FALCON RESERVE FILING NO. 1

STORM & PCM CONSTRUCTION PLANS

OCTOBER 2025

PRIVATE FULL SPECTRUM DETENTION BASIN (POND 1)
SCALE: 1"=20'

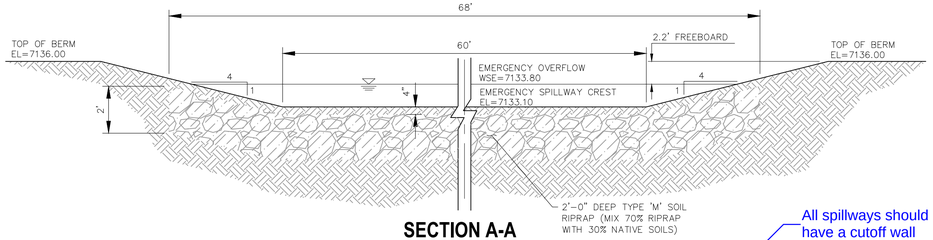
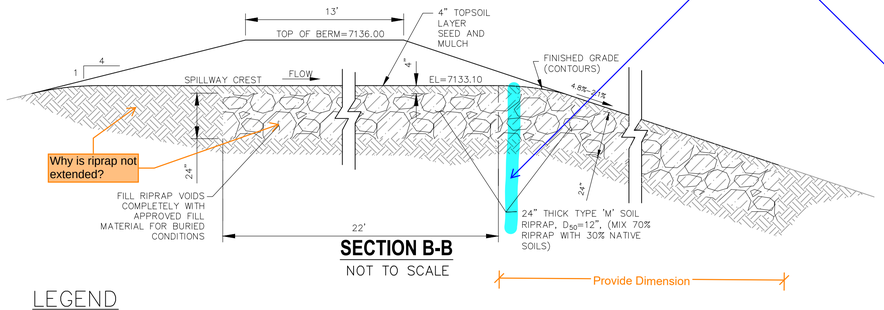
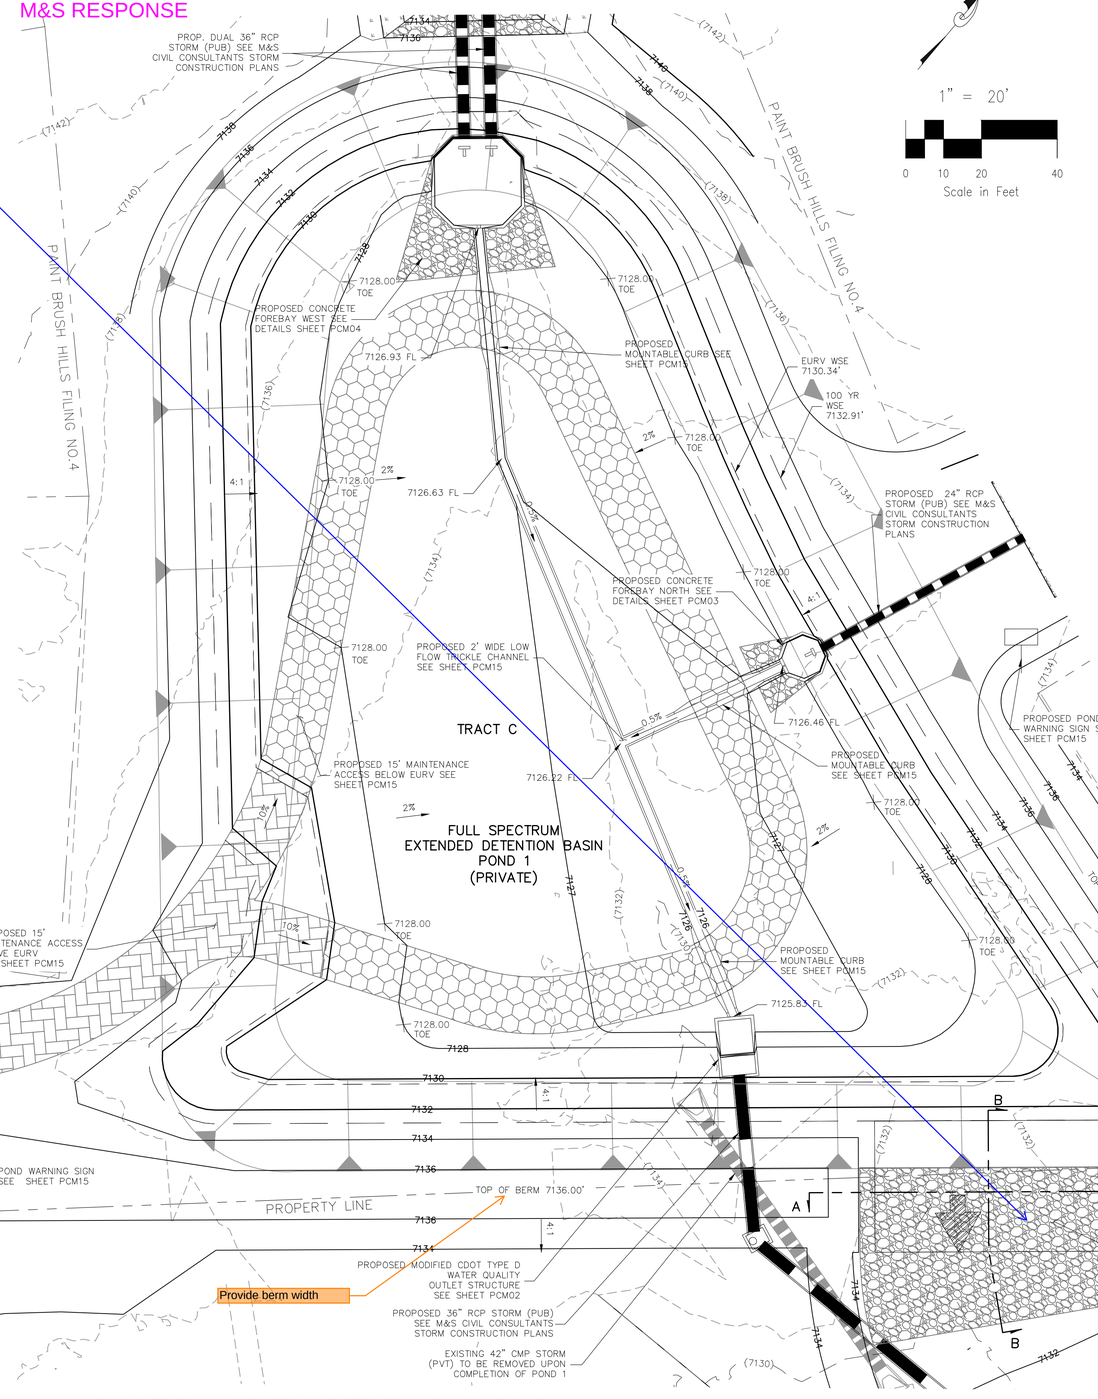
All spillways should have a cutoff wall

Provide Dimension

DPM - PONDS 1, 2, & 3
1. ADDED CUT-OFF WALL WITH DETAIL (CDOT REF DTL)
2. ADDED DIMENSIONS, ADJUSTED RIPRAP EXTENTS TO 10' MIN. BEYOND POND EMBANKMENT
3. EMERGENCY SPILLWAY PER CITY AND MHFD STANDARDS
4. CALLED OUT BERM WIDTHS IN PLAN AND SECTION VIEW

M&S RESPONSE

POND 3 & SOUTH PROPOSED DRAINAGE SWALE

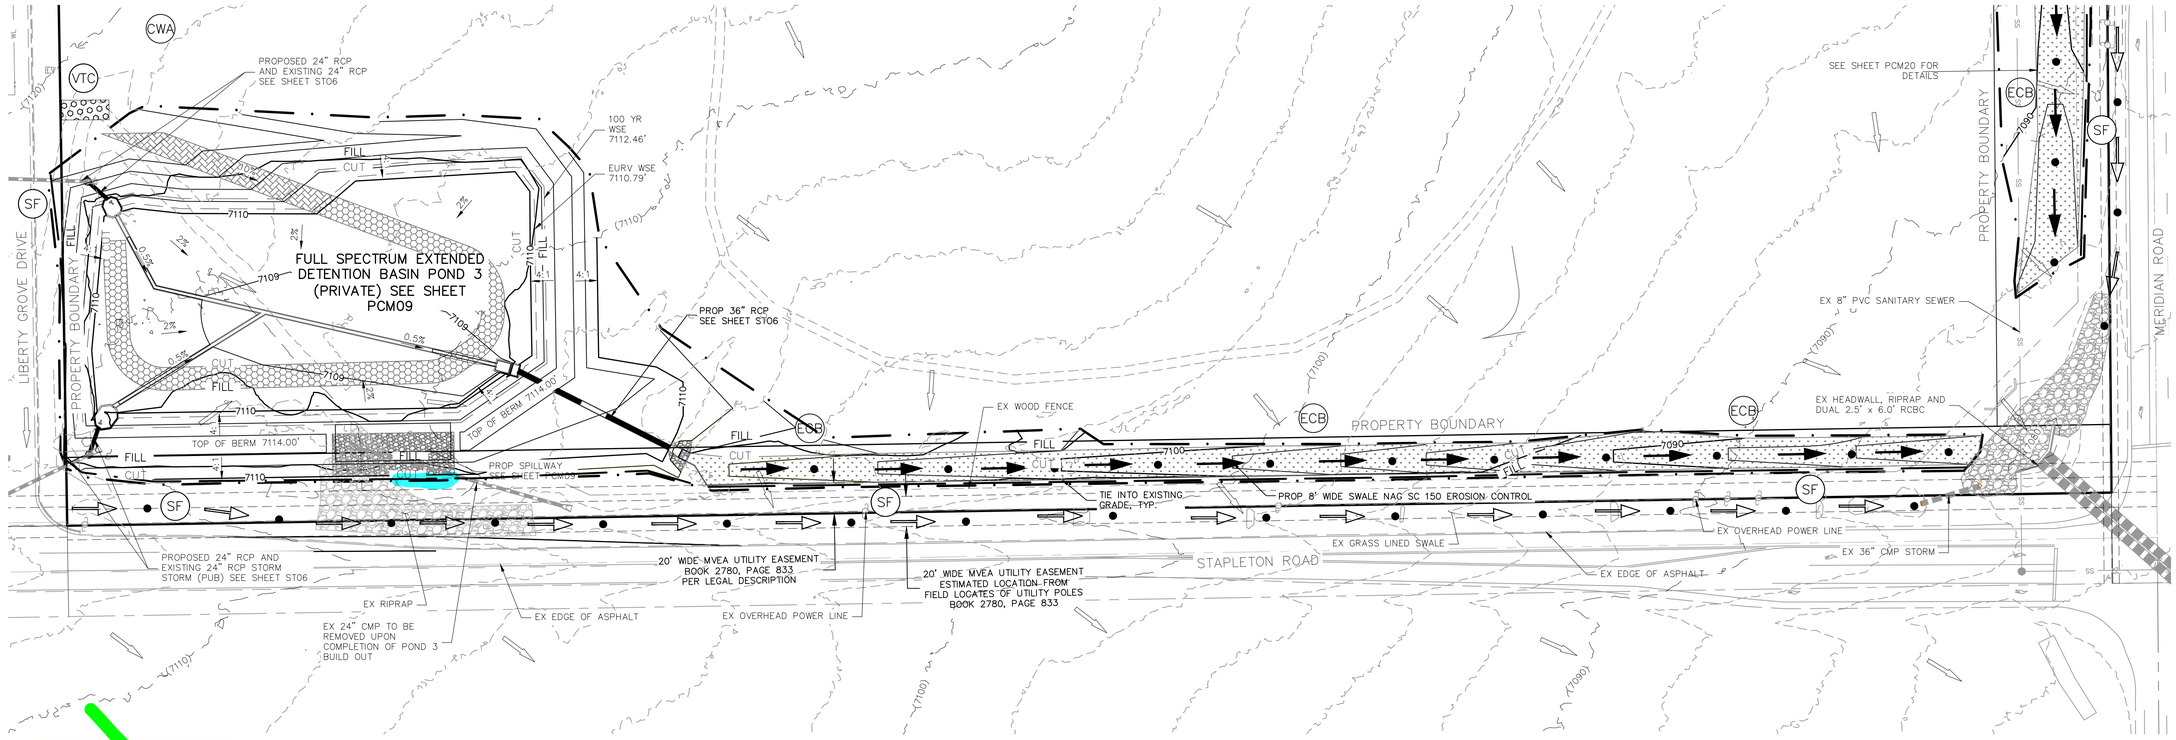
GEC Checklist Item x - Provide SCL detail or remove from legend.

GEC Checklist Item G - show existing utilities.
GEC Checklist Item C - Label property parcel numbers

GEC Checklist Item K - Show existing vegetation or provide a note describing vegetation on site

Info added as requested
